Architect's Supplemental Instructions

Architect's ASI No: 019

Project:
Webster University
Interdisciplinary Science
Building

Description: ASI – 019 (RFI-193,RFI-208 & RFI-212)

RISERS - PLUMBING

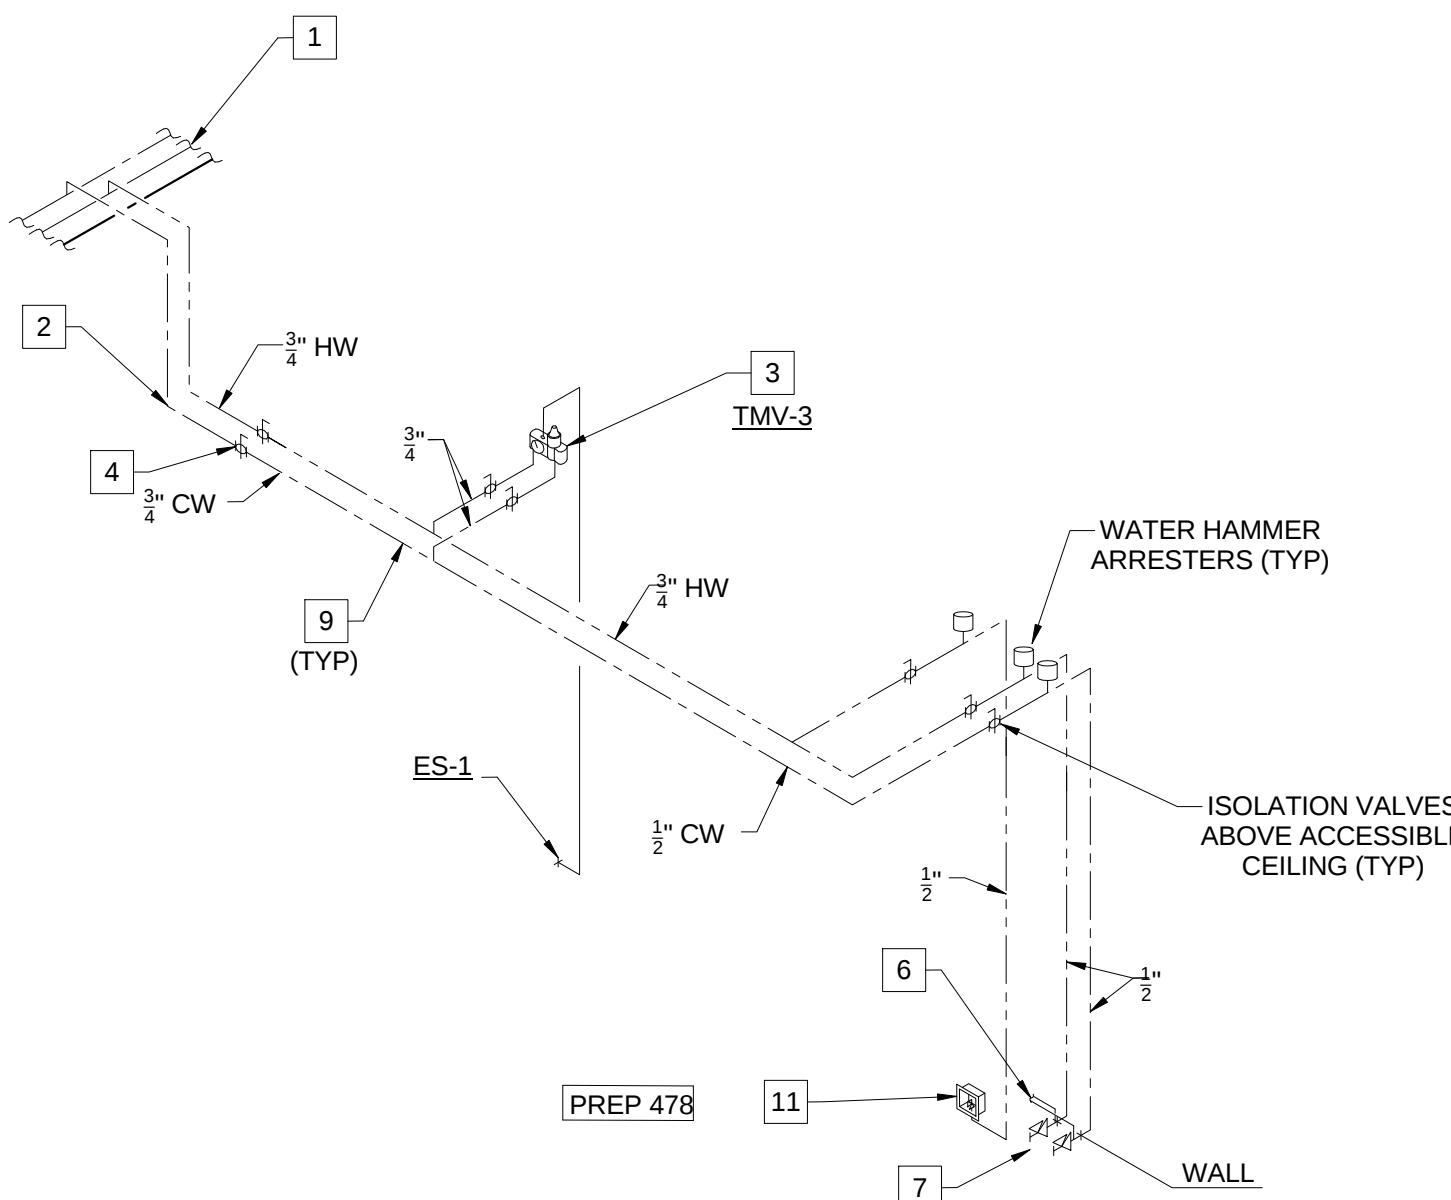
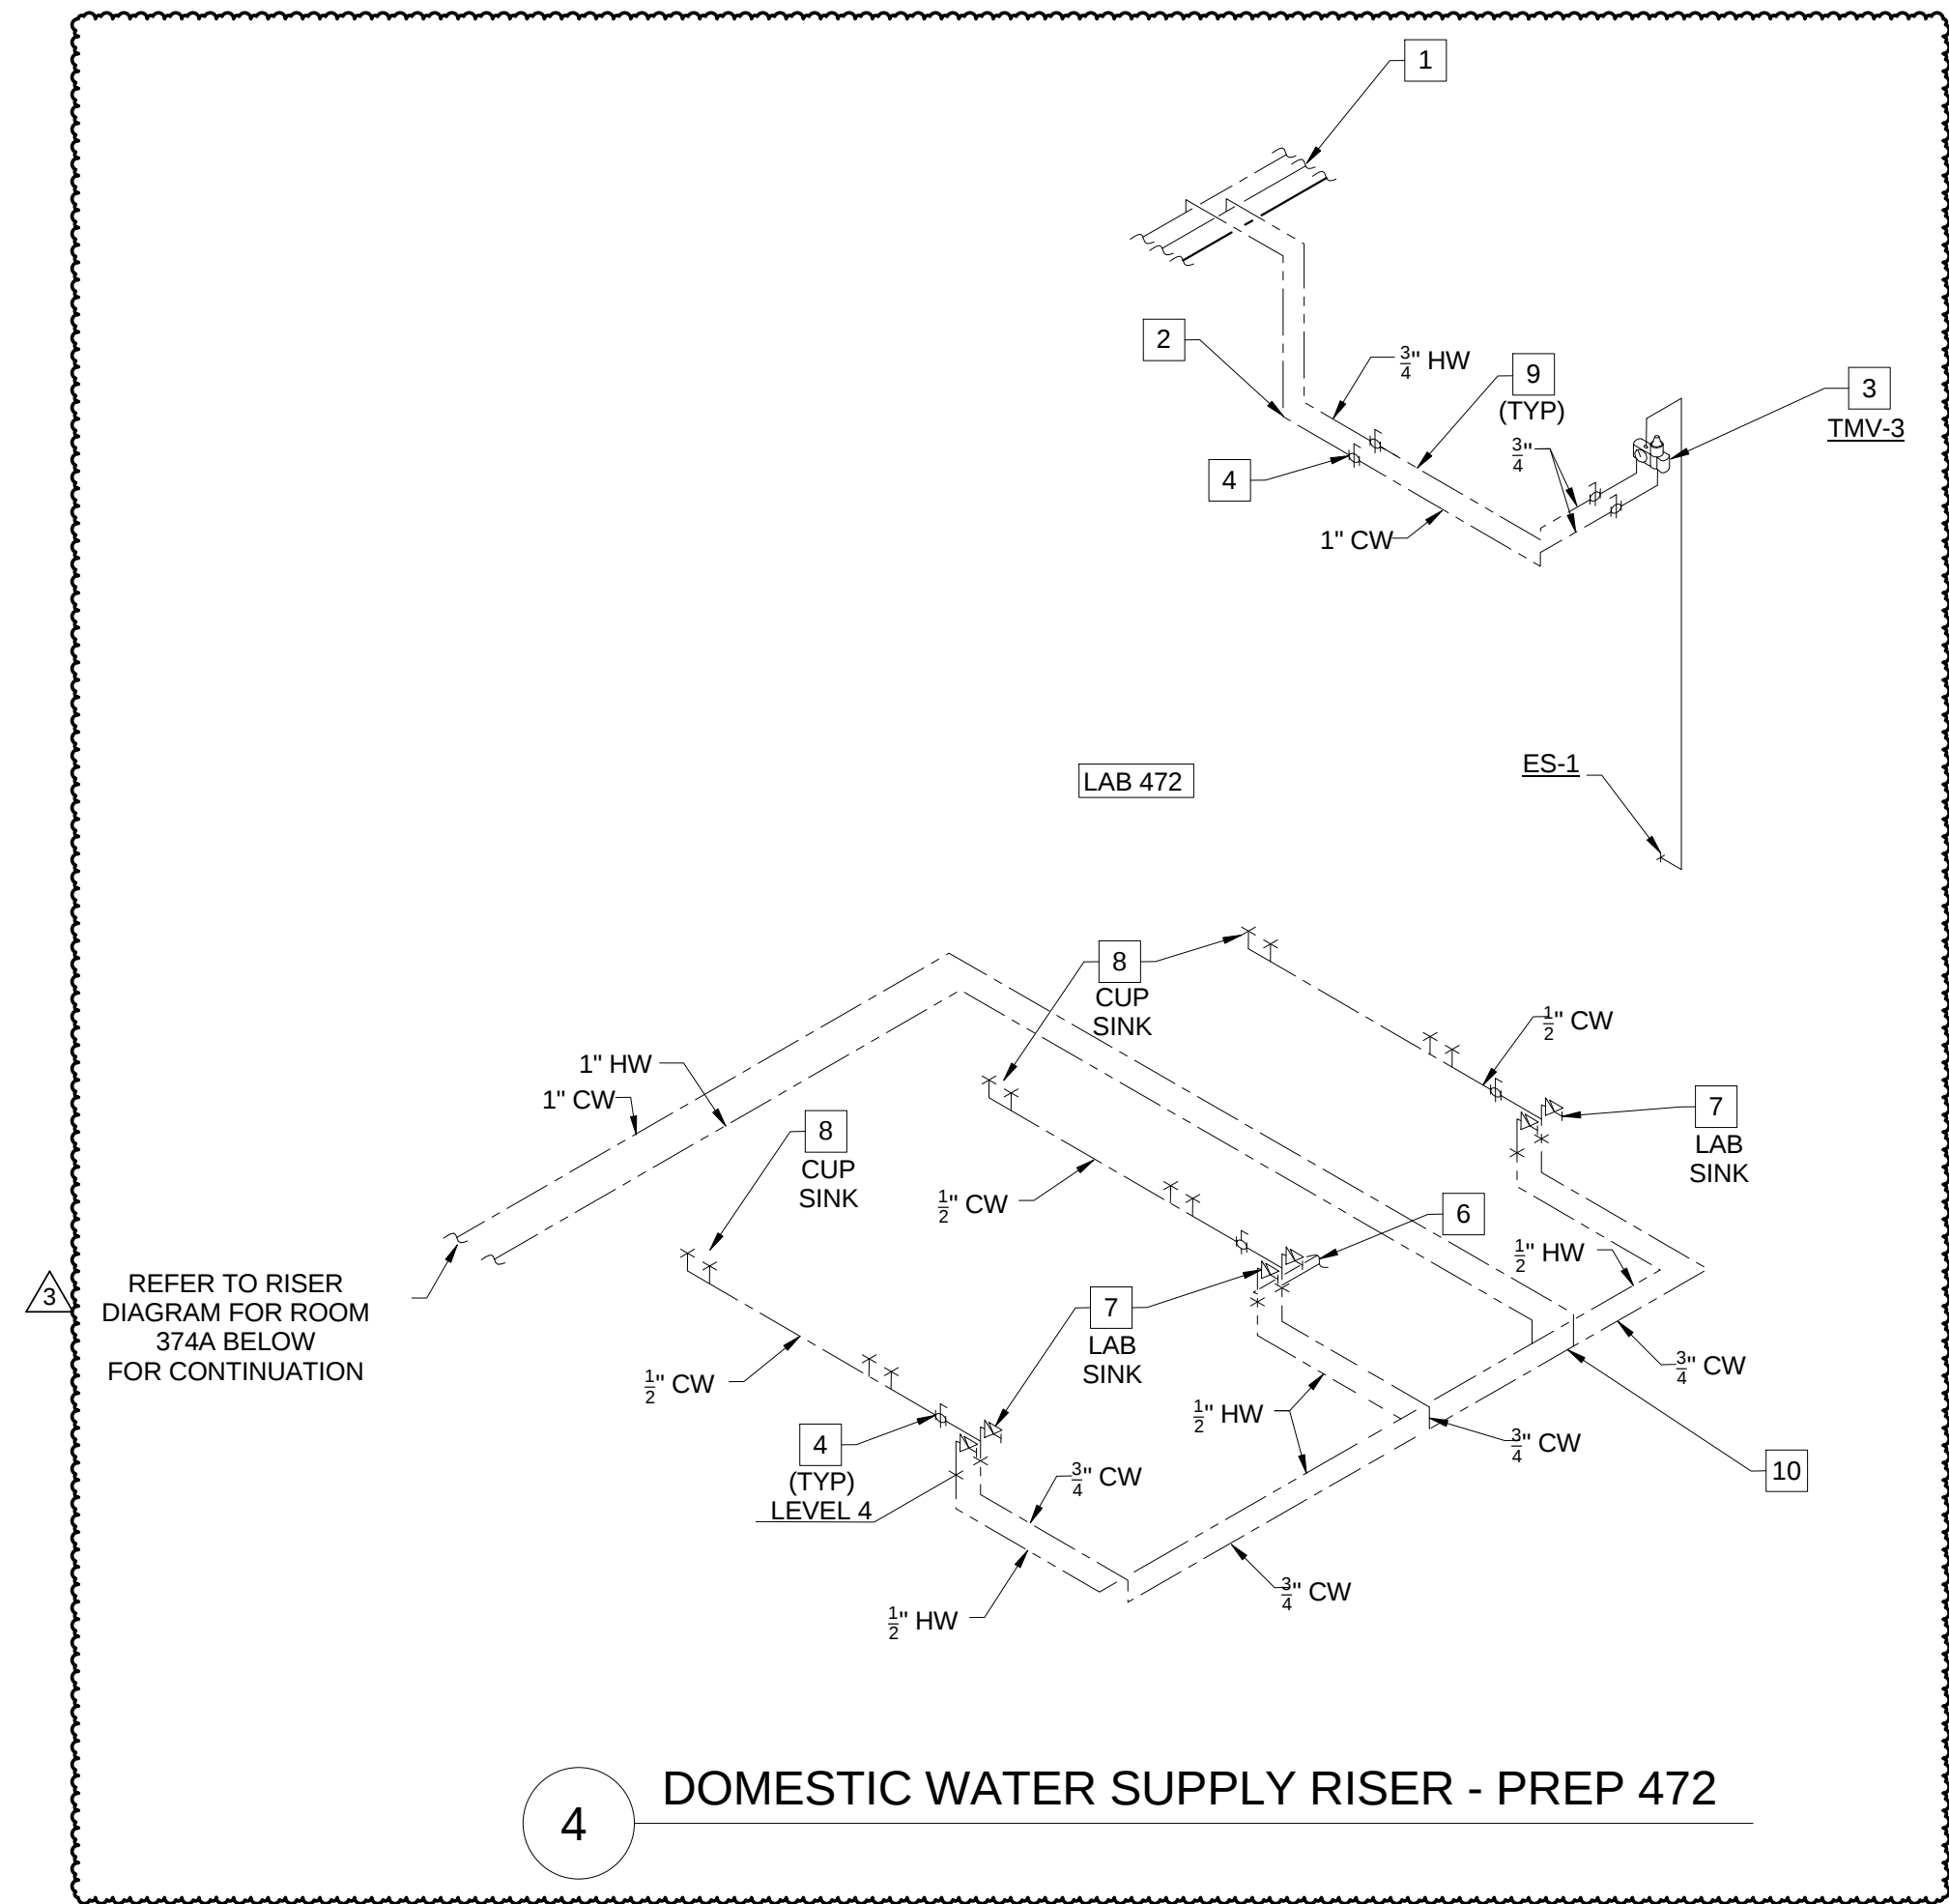
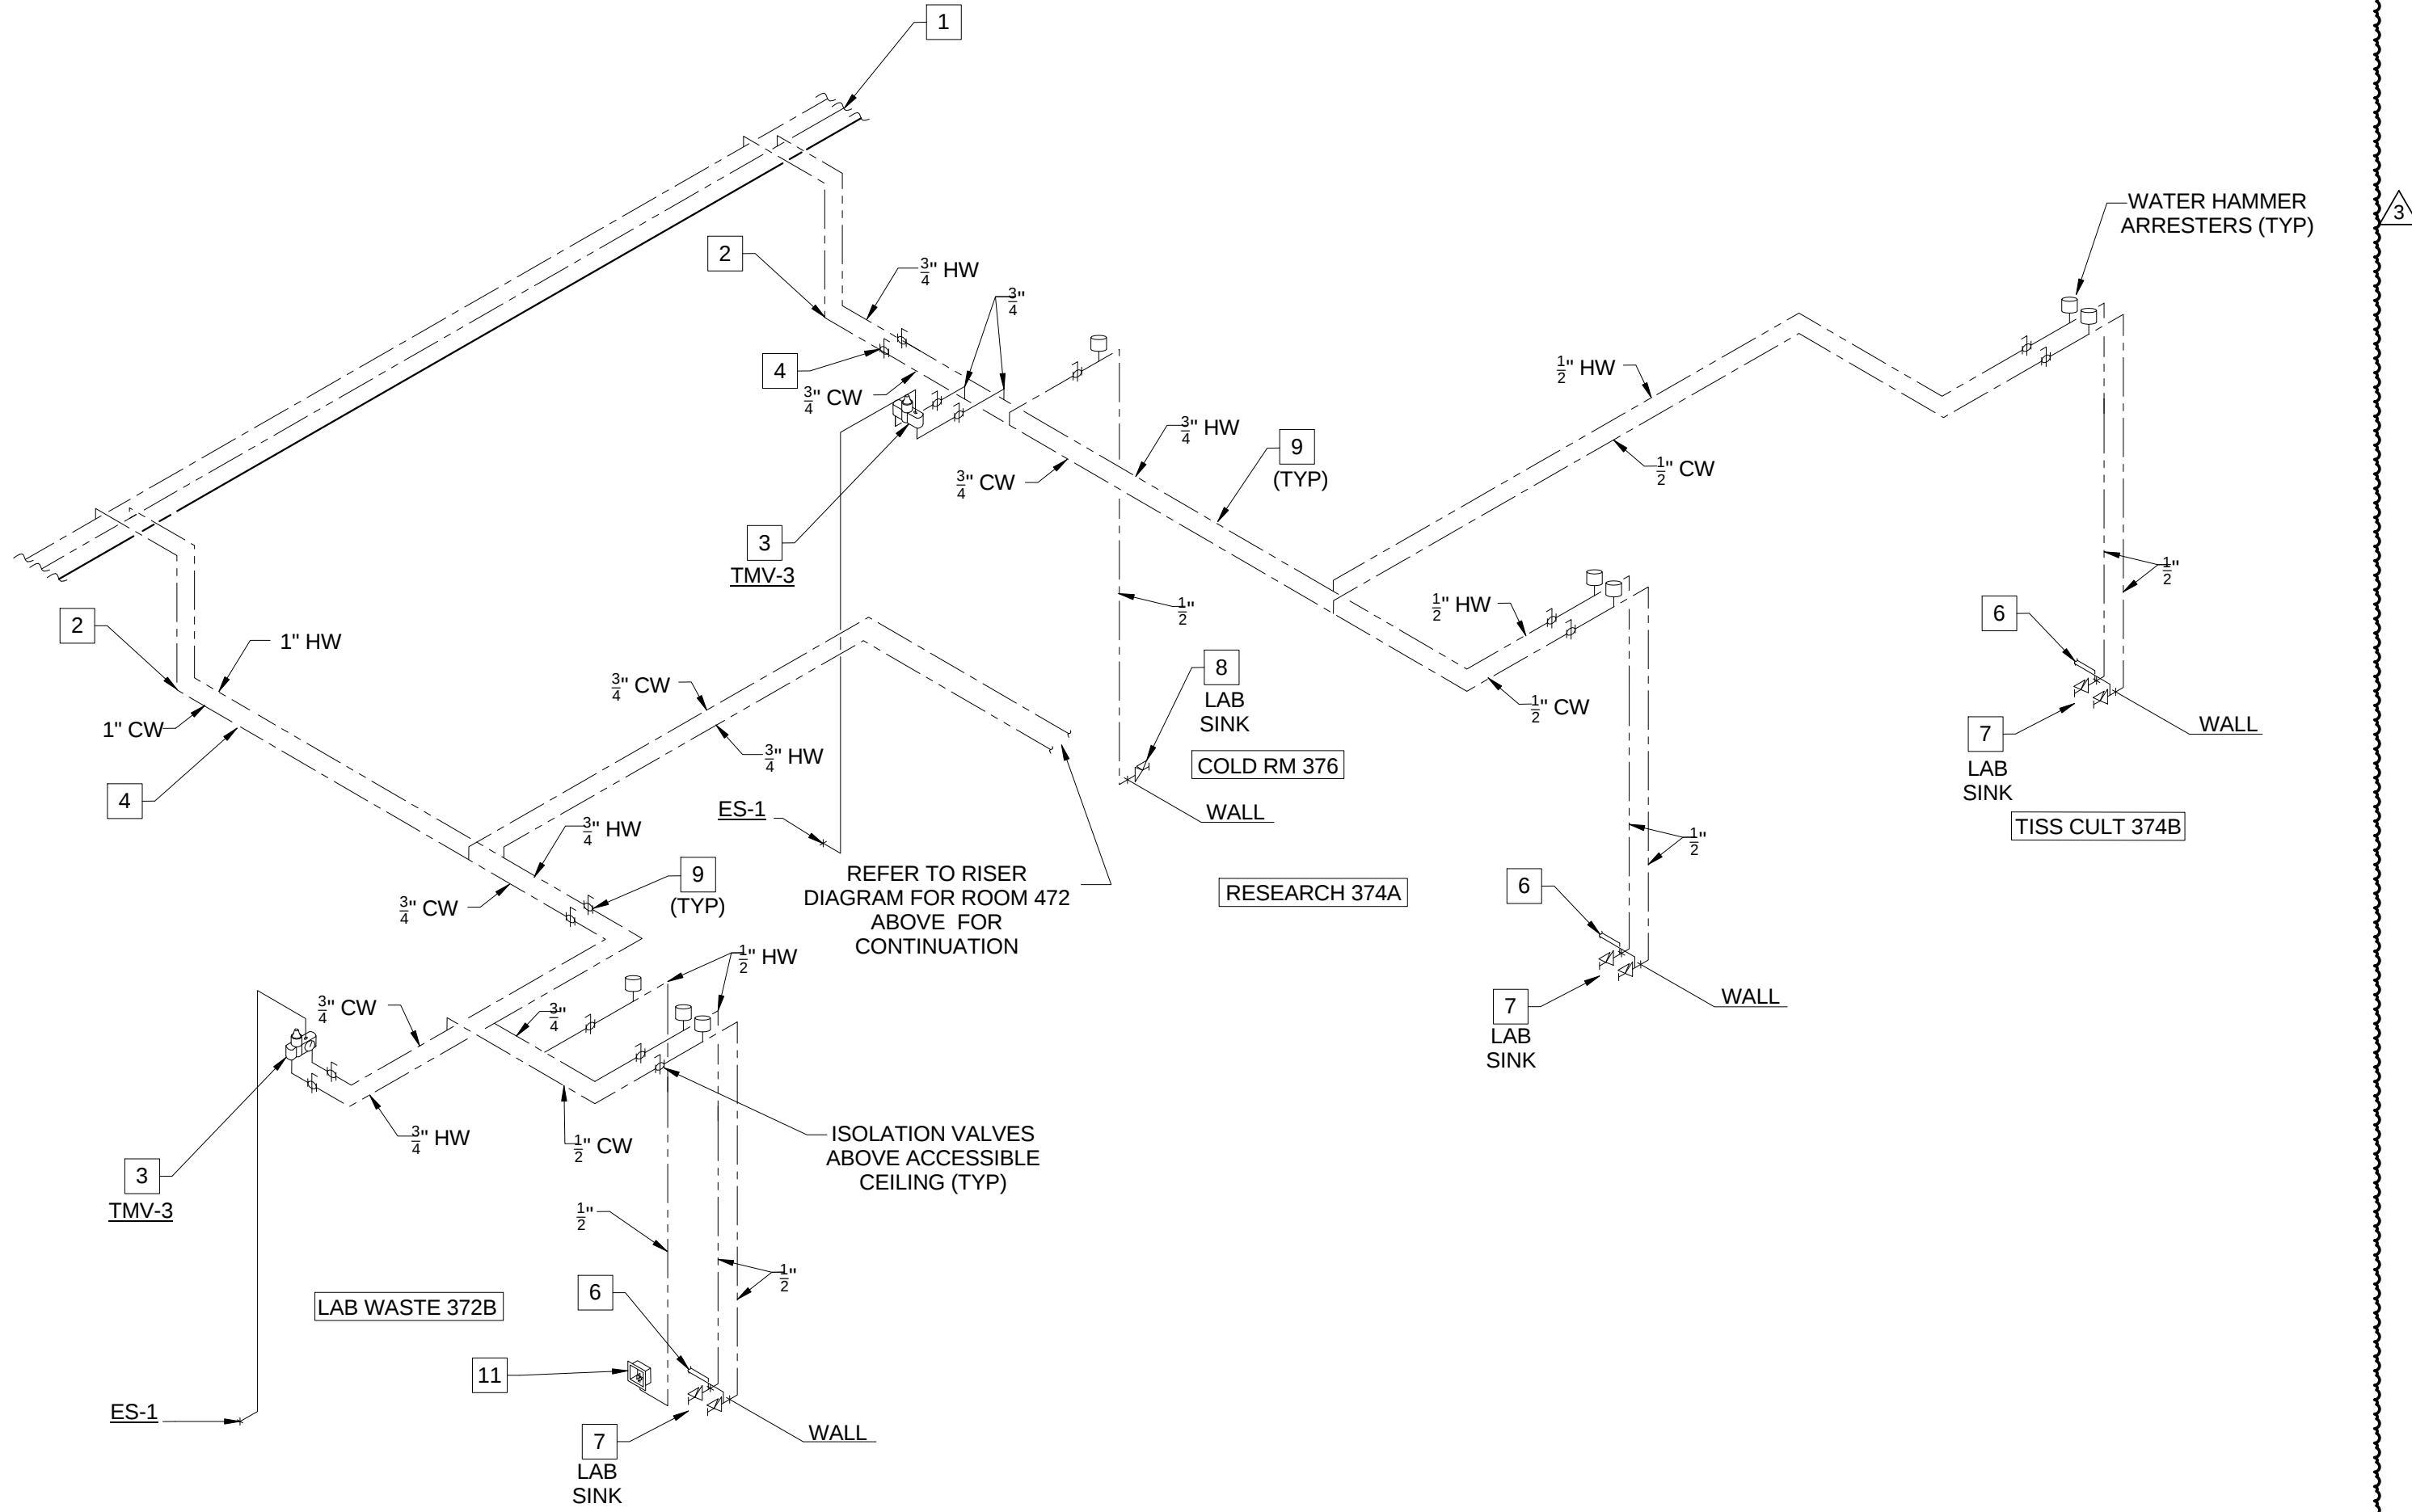
RFI-208,(P0103.A/P0407/P0409); request that attention be bought to the issue of length of the hot water run serving the island sink in Room 472 Chem Lab-General and Room 480 Chem Lab-Organic. The run of non-recirculated dead-end piping from the main to the sink would result in a long wait for hot water. As result water supplier to sinks were removed from the 4th Floor Level and moved to the 3rd Floor Level. In Room 478, some alignments were shorten, reducing the amount of 1-inch diameter piping by approximately 84 linear feet and in Room 472, alignments were shorten reducing amount of 1-inch diameter by 54 linear feet. Other pipe sizes were modified as well. Refer to drawing P0104.A and drawing P0409 for all associated modifications.
